MEMORANDUM

DATE: December 19, 2013
TO: Nicholas Rystrom, City Engineer, City of Revere
FROM: Seth Asante, MPO Staff
RE: Federal Fiscal Year (FFY) 2013 Community Transportation Technical Assistance Program: Safety Improvements for Pedestrians at Park Avenue and Dale Street Intersection in Revere

Proposed improvement submitted by City of Revere for review by MPO staff

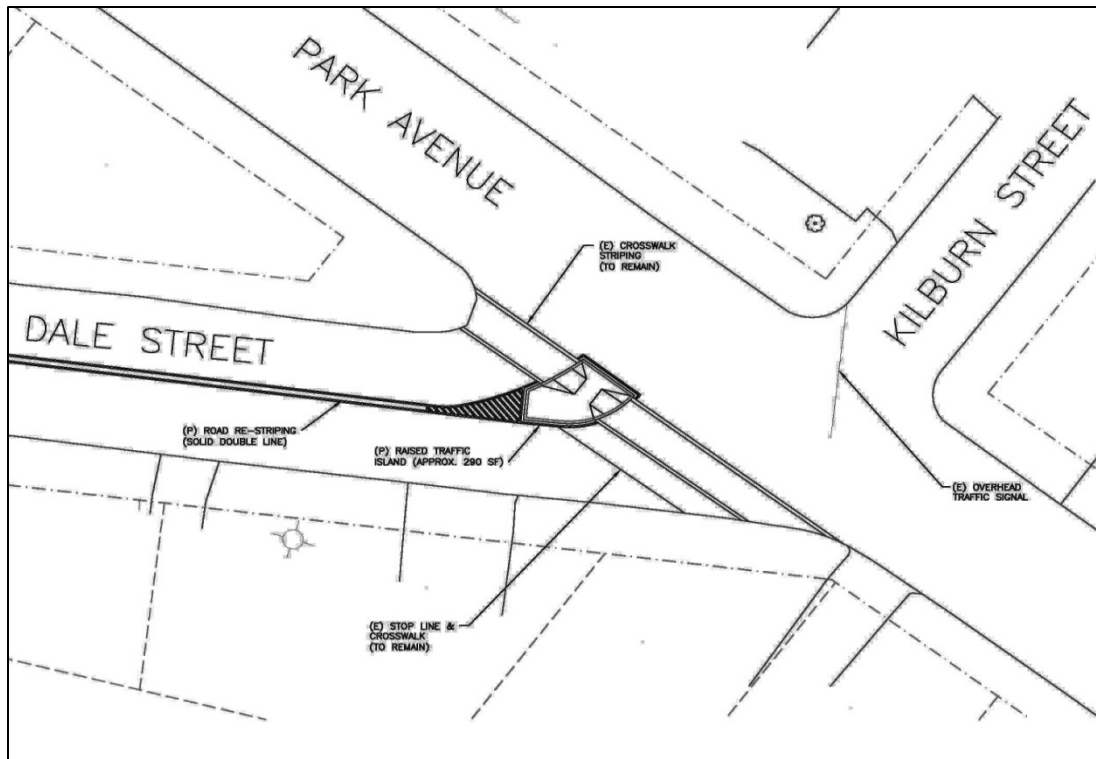
Based on discussions with the city engineer, the field visit, and review of the city's proposal, MPO staff concluded that the proposed traffic island would reduce the speed of vehicles turning left from Park Avenue onto Dale Street and channel traffic into and out of Dale Street. The traffic island would allow left-turning Park Street vehicles to approach Dale Street more perpendicularly and at a slower speed. It also would allow motorists northbound on Dale Street to approach Park Avenue more perpendicularly and improve their sight distance.

FIGURE 1
Refined Alternative Proposed by MPO Staff

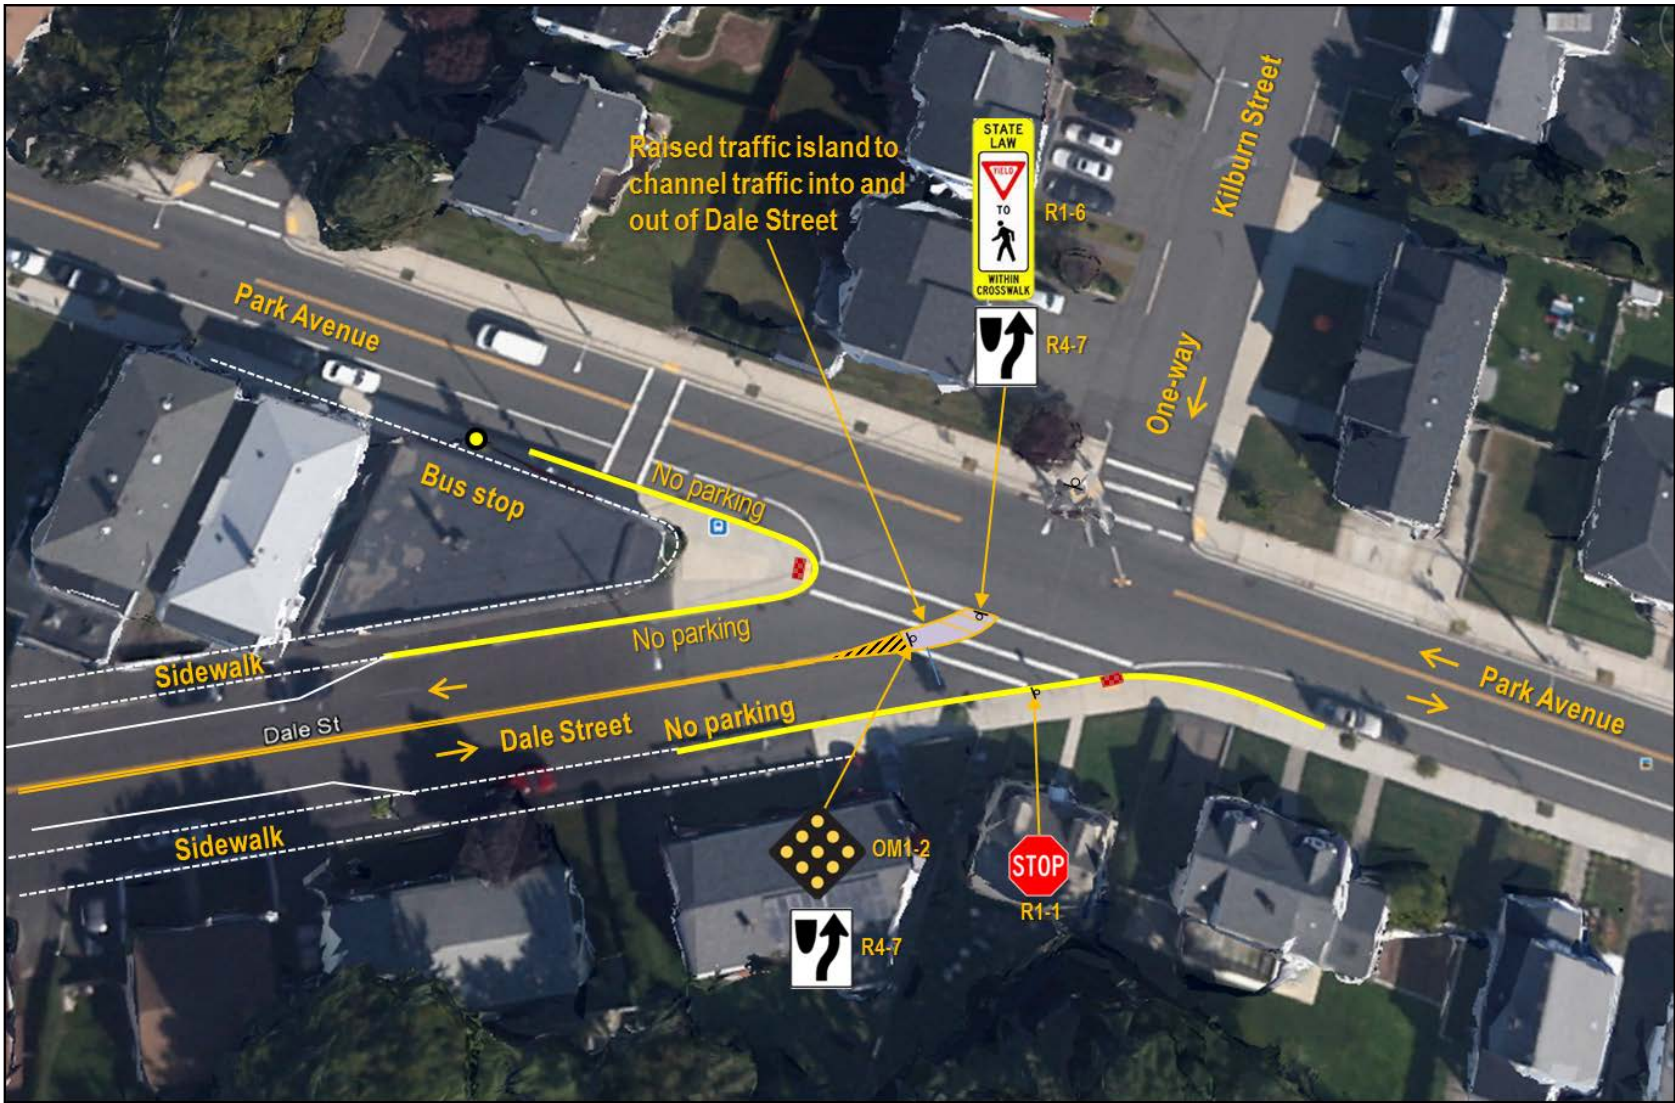
In addition, MPO staff proposes the following refinements (shown in Figure 1) to increase safety:

- Align the traffic island so that it would not restrict truck and bus movements (Figure 1). The MBTA bus route 110 uses Dale Street on snow days to avoid a hill on Park Avenue west of the intersection.
- Prohibit on-street parking at the intersection to improve visibility for motorists and pedestrians, and traffic flow on Dale Street.
- Install R4-7 (keep right) sign to direct traffic to pass only to the right-hand side of the traffic island.

- Install R1-6 (state law yield to pedestrian within crosswalk) sign to remind motorists of laws regarding right-of-way at an unsignalized pedestrian crosswalk.
- Install OM1-2 (object marker) sign to mark the obstruction (traffic island) within the roadway.
